Reference: TIPM Design Review

This voluntary submission contains FCA US LLC's ("FCA US") responses to the various informal information requests related to Totally Integrated Power Module-7 ("TIPM-7"). These requests were in response to various design reviews and meetings between the Office of Defect Investigations ("ODI") and FCA US Safety Office.

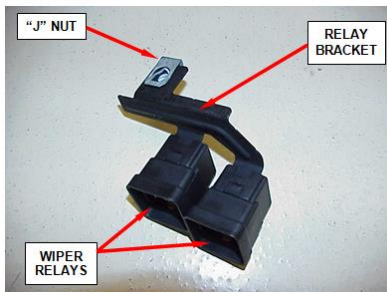
6. Please provide a picture of the remedy external relay used for J28.

A6. The relay used for the J28 remedy is shown below.

- CBL3J280AA Wiring Harness Overlay Package
